VIRGIN ISLANDS WATER & POWER AUTHORITY
TRANSMISSION & DISTRIBUTION DIVISION

PROJECT NAME: RFP FOR CONTAINER PORT UNDERGROUND PROJECT

PROJECT REFERENCE: ADDENDUM No. 2

Addendum No. 2
Issue Date: January 13, 2020

1 BITUMINOUS PAVEMENT REPLACEMENT
 SCALE: 1" = 1'-0"
 C-07

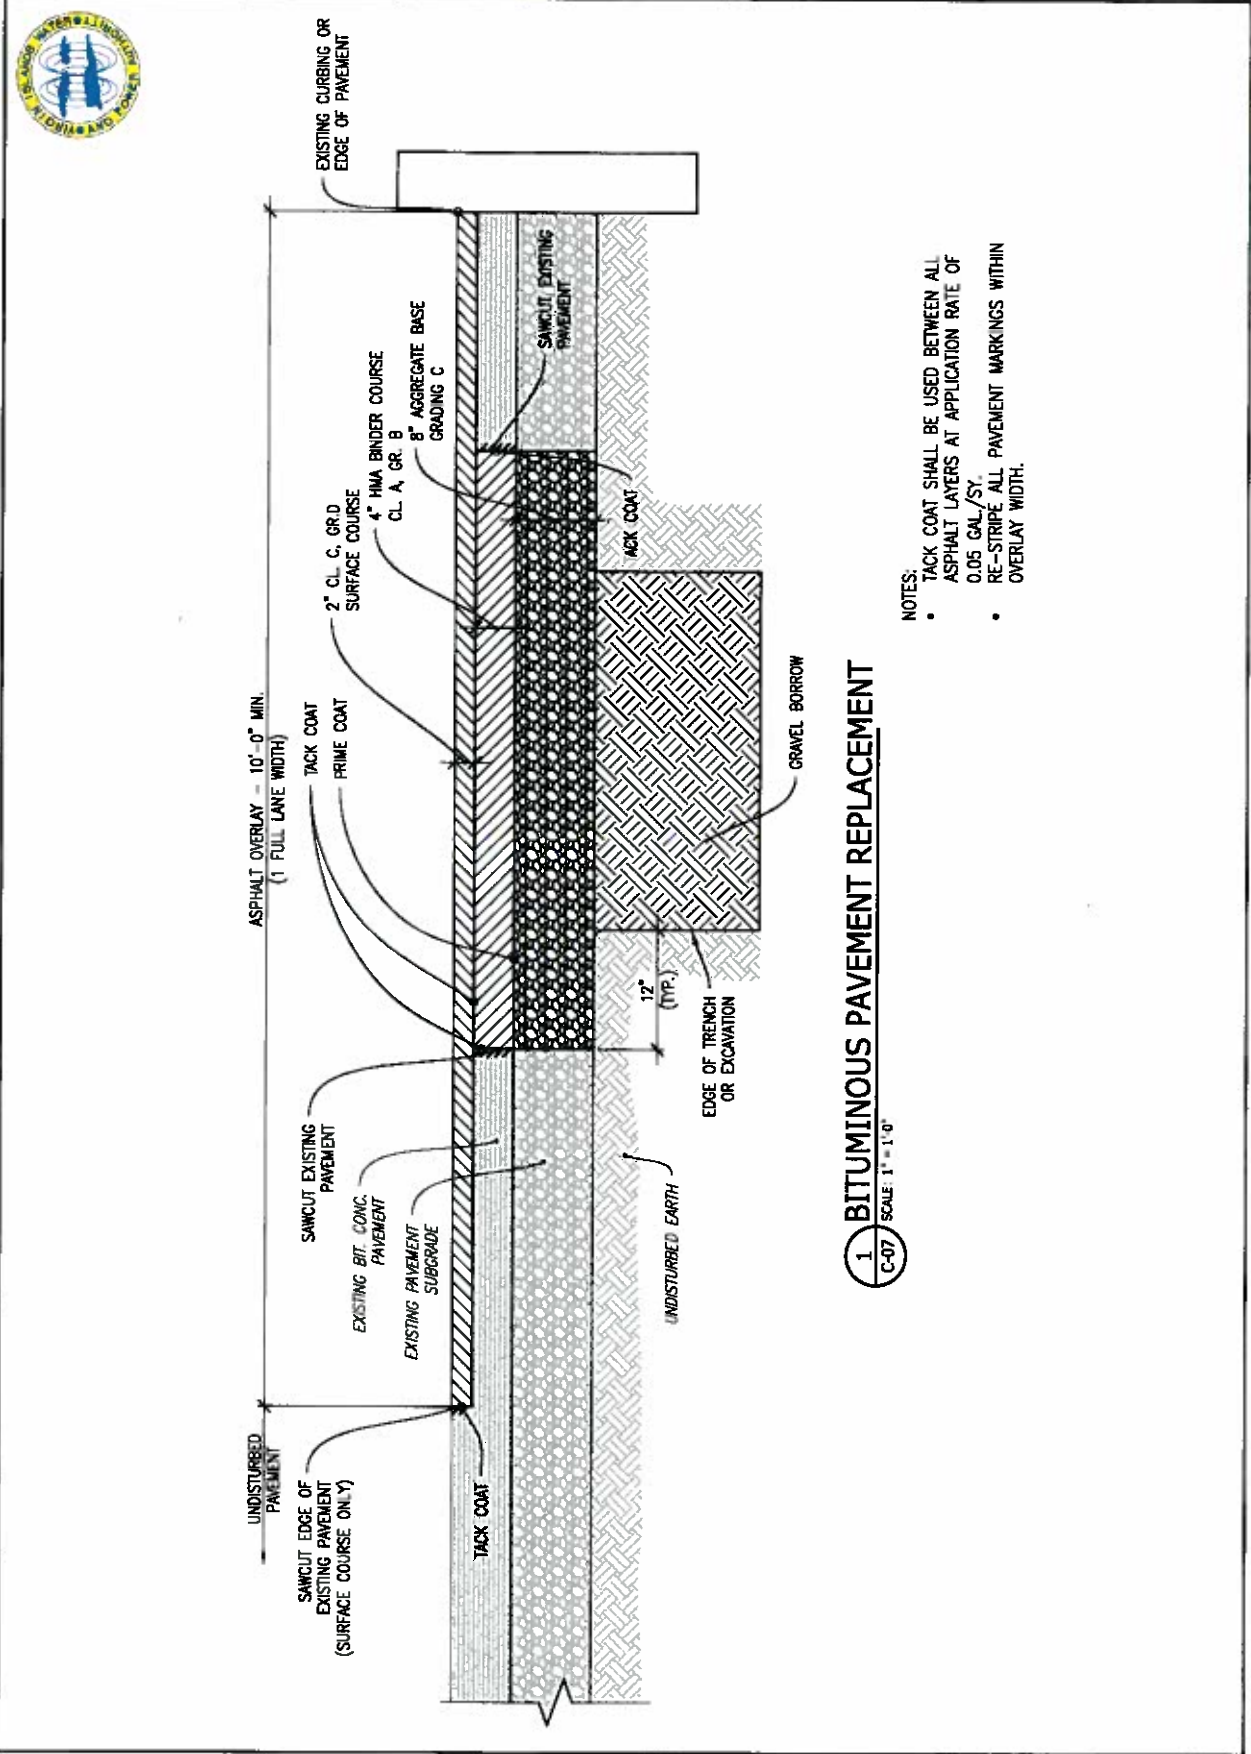
1. Please confirm that for the asphalt repair is milling (2") and asphalt (2") of a single lane 12 feet wide.

Refer to attached drawing SKC-01, dated October 24, 2019. This will be the standard utilized.
